HISTORIC AND DESIGN REVIEW COMMISSION

HDRC CASE NO: 2022-011
ADDRESS: 506 MADISON ST
LEGAL DESCRIPTION: NCB 750 BLK 9 LOT NW 118.17 FT OF 3
ZONING: RM-4,H
CITY COUNCIL DIST.: 1
DISTRICT: King William Historic District
APPLICANT: Eduardo Garcia
OWNER: Jill Quick-McCrosky/SCUDDER WILLIAM L
TYPE OF WORK: Exterior modifications, construction of a 2-story rear addition
APPLICATION RECEIVED: December 20, 2021
60-DAY REVIEW: Not applicable due to City Council Emergency Orders
CASE MANAGER: Stephanie Phillips

1. Demolish the non-original rear addition.
2. Construct a 2-story addition measuring approximately 950 square feet, to include a covered 1-story rear porch.

OVERALL SITE PLAN

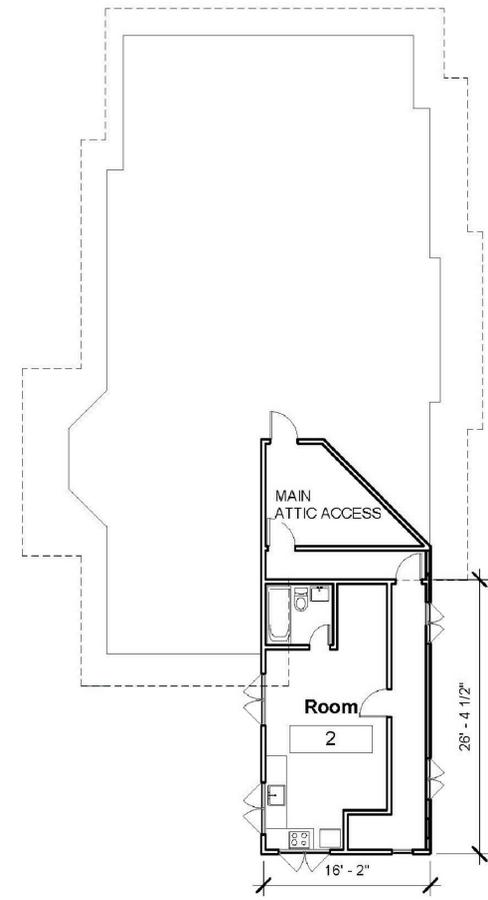
- d. FOOTPRINT – The applicant as proposed to construct a new 2-story addition to the primary structure totaling approximately 950 square feet. The Historic Design Guidelines for Additions stipulate that new additions should not double the footprint of the primary structure in plan. Staff finds that the proposal generally meets this guideline.

FRONT ELEVATION (NORTH)

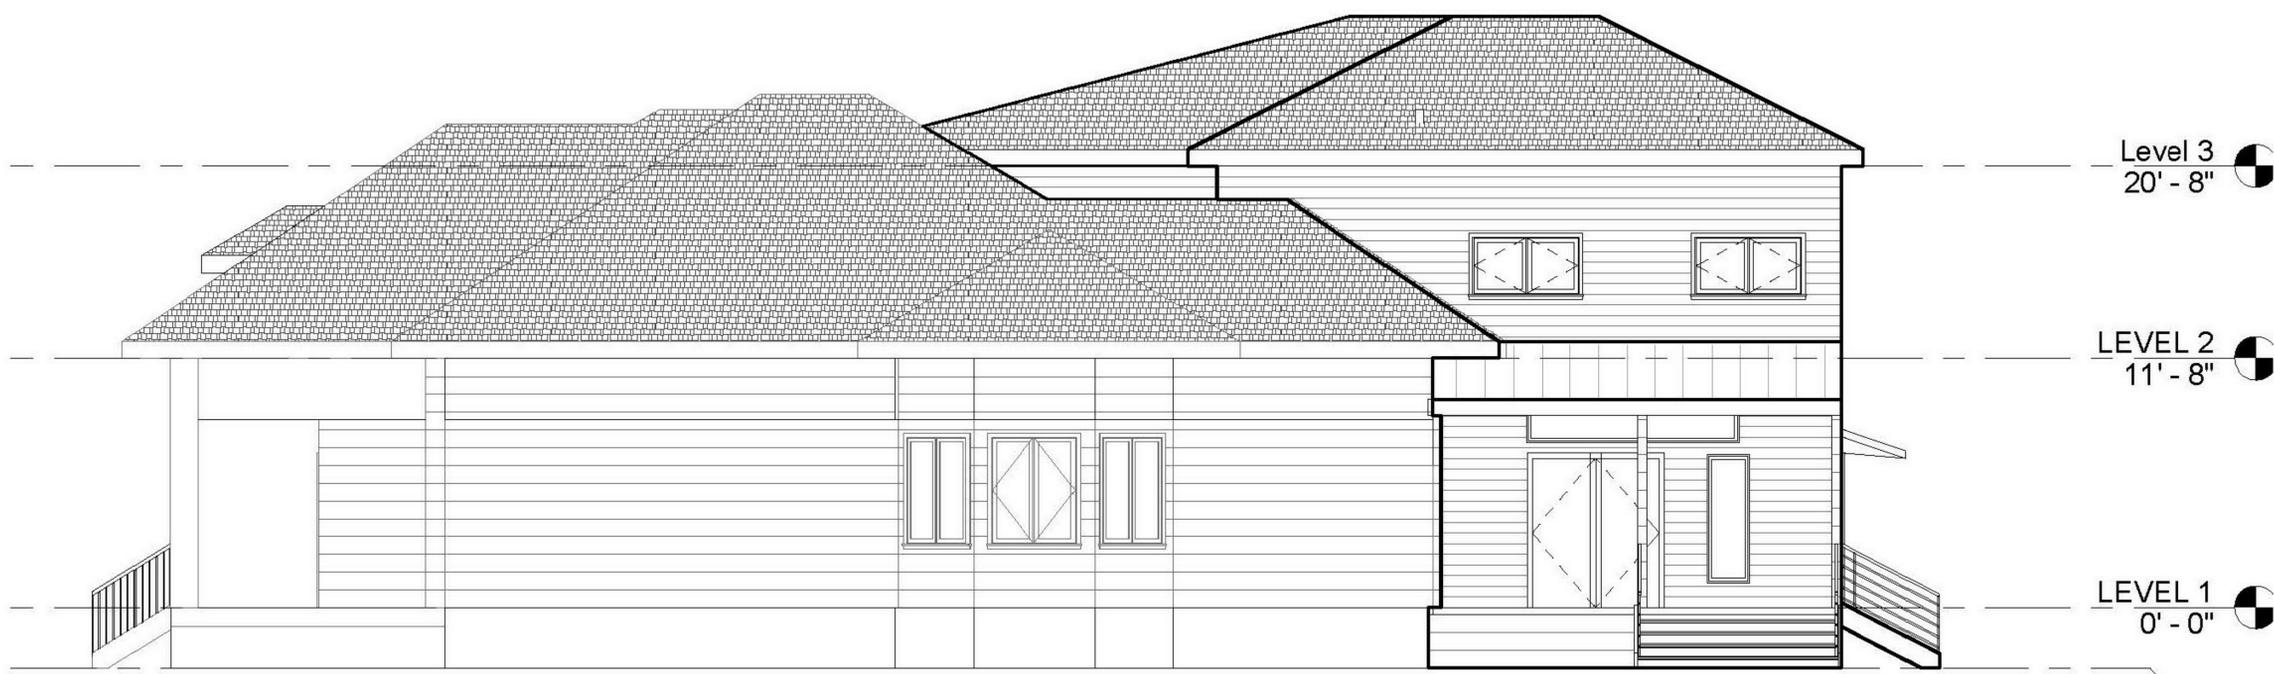
- f. SCALE – The proposed addition is 2-story and will be taller than the historic structure's tallest ridge in height. The peak of the addition's ridgeline will be visible from the front elevation. Due to the location of the addition, which is towards the eastern edge of the property line, a 2-story scale will not be concealed by the tall hip peak of the primary historic structure. The Historic Design Guidelines state that new additions should be subordinate to the primary structure in height. Staff finds that a 2-story addition may be appropriate, but finds that the ridge height as proposed should be lowered to be subordinate to the primary historic structure's ridgeline to minimize the impact of the addition on the primary historic structure and the view from the public right-of-way. This can be accomplished by lowering the plate heights, lowering the pitch of the roof, or other methods. As proposed, the clipped hip that connects the primary historic structure's roofline to the roofline of the new addition results in a condition where the mass of the addition overwhelms the rear elevation of the historic structure. Staff also finds that the addition should be separate from the existing ridgeline to minimize the overall mass of the second story on the primary historic structure. Staff finds that the applicant should explore ways to separate the historic

structure and addition via a camelback approach, exploration of a different roofline configuration, or similar strategy.

- i. ROOF FORM – As noted in finding f, the proposed 2-story rear addition will utilize a primary hip form with a clipped, lower-pitched hip that connects the addition to the primary structure. According to the Guidelines, roof forms on additions should respond to the roof form of the primary structure and predominant roof forms used historically in the district. As proposed, the hip that connects the primary historic structure’s roofline to the roofline of the new addition results in a condition where the mass of the addition overwhelms the rear elevation of the historic structure. Staff also finds that the addition should be separate from the existing ridgeline to minimize the overall mass of the second story on the primary historic structure. Staff finds that the applicant should explore ways to separate the historic structure and addition via a camelback approach, exploration of a different roofline configuration, or similar strategy.

- i. That the applicant modifies the proposed addition’s roof form to separate the addition from the historic structure and visually reduces the weight and mass of the proposed addition’s roof form as noted in finding i. Updated elevations are required for final approval.

- ii. That the applicant reduces the height of the rear addition to be subordinate to the primary structure as noted in finding i. Updated elevations are required for final approval.

REAR ELEVATION (SOUTH)

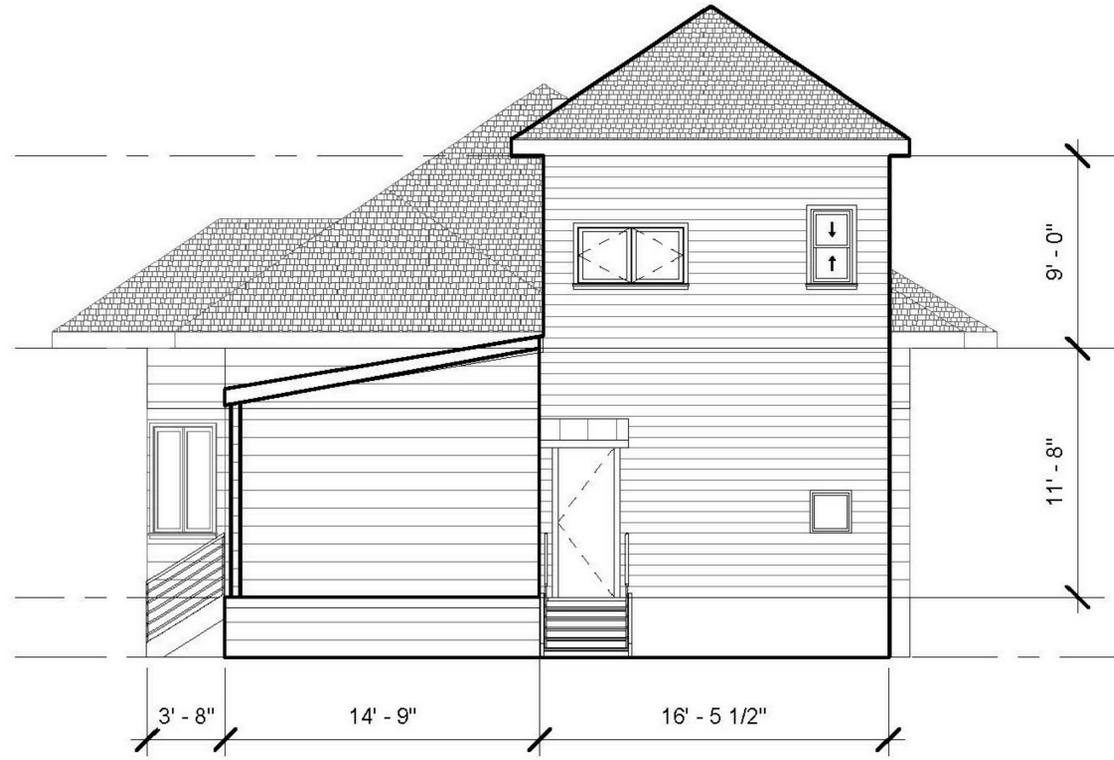
- k. ELEVATIONS – Though not included in the application request, the submitted elevations appear to include modifications to the fenestration on the primary historic structure, including new square windows and the removal of the rear two over two window on the western portion of the rear elevation. The applicant is required to submit detailed information on any exterior changes to the primary structure for final approval. Replacement of or modifications to original windows are not recommended.

- iv. That the applicant includes detailed information on any proposed modifications to the primary historic structure as noted in finding k. The two over two window on the western part of the rear elevation, as well as windows on the side elevations that are indicated on floor plans as being enclosed or modified, should remain. All elevations should be fully accurate. If window modifications or replacement is proposed on the historic structure, the applicant is required to submit a comprehensive window schedule and photos indicating the condition of existing windows. Window replacement is not recommended.
